SUBJECT: Forwards addl info re schedular commitments for items in
 draft technical evaluation rept on control of heavy loads.

Re: Turkey Point Units 3 & 4
Docket Nos. 50-250 and 50-251
Control of Heavy Loads
Draft Technical Evaluation Report

Re: Turkey Point Units 3 & 4
Docket Nos. 50-250 and 50-251
Control of Heavy Loads

FIGURE 2a - SAFE LOAD PATH

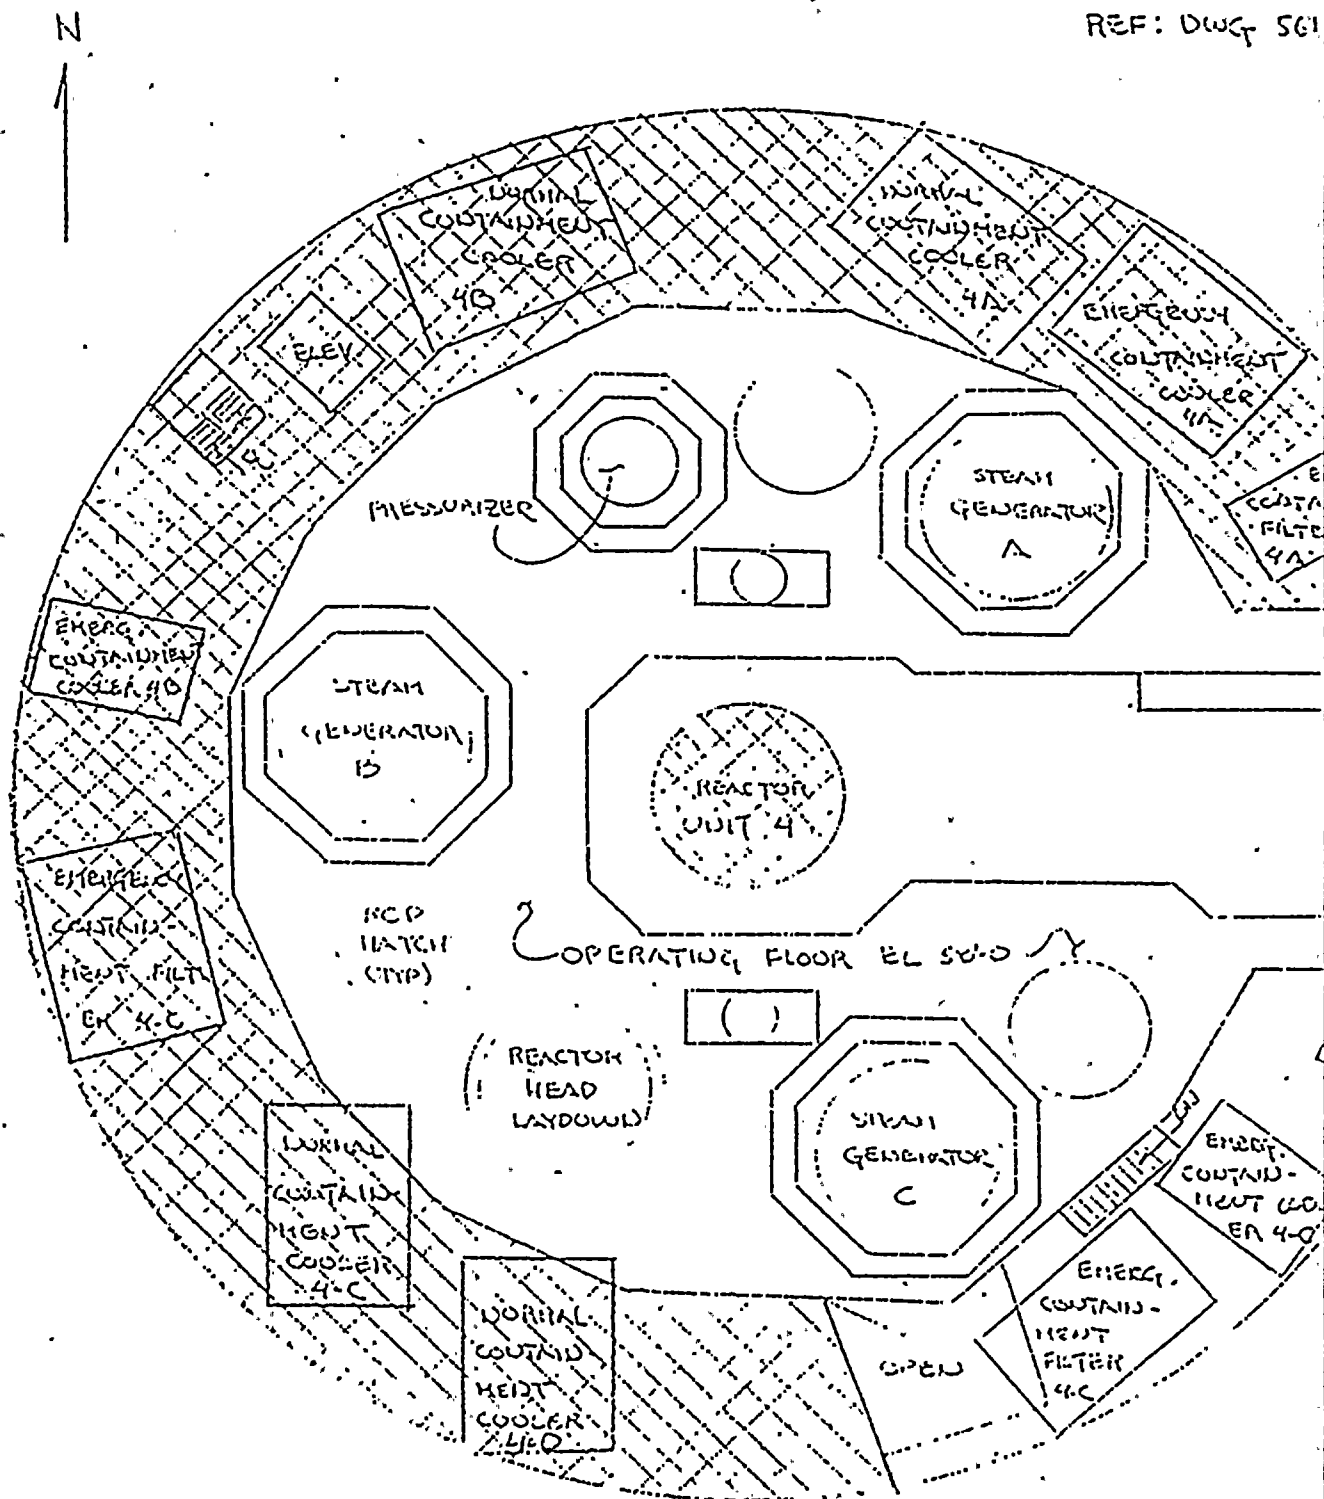
Turkey Point Units 3 and 4 partially comply with Guideline 1. In order to comply with this guideline, the Licensee should perform the following:

1. Define safe load paths where practical. The use of exclusion areas should be limited to miscellaneous maintenance areas and lifts where the designation of individual load paths is impractical.
2. Verify that heavy loads and their safeload paths have been identified in the plant procedure for controlling heavy loads.
3. Verify that the selection of load paths considers the location of structural members and beams.
4. Verify that safe load paths have been clearly marked on floors or structures.
5. Verify that deviations from load paths require written alternatives approved by the plant's safety review committee (or equivalent).

The safe load path areas as defined in the initial response to the NRC generic letter have been revised in a subsequent response to NRC addressing the specific requirements of NUREG-0612. These safe load path areas and restricted zones were developed by the FPL Power Plant Engineering Department. Copies of these safe load path drawings are attached. These drawings indicate certain areas where the handling of loads greater than 1760 pounds is restricted. In some areas the handling of loads greater than 5 tons is restricted. The bases for these restrictions are the different capabilities of the structures in the area to withstand a dropped load and the potential for damage to irradiated fuel and safe shutdown equipment.

Florida Power & Light Company does not concur that marking the safe load paths on the floors or structures is a practical or necessary means of informing the operator of the safe areas. The sketches which are readily available to the operator at the hoist controls, are easy to understand and serve the same purpose as floor markings. Also, floor markings can be obstructed by equipment and are not feasible in certain areas (e.g. the refueling pool).
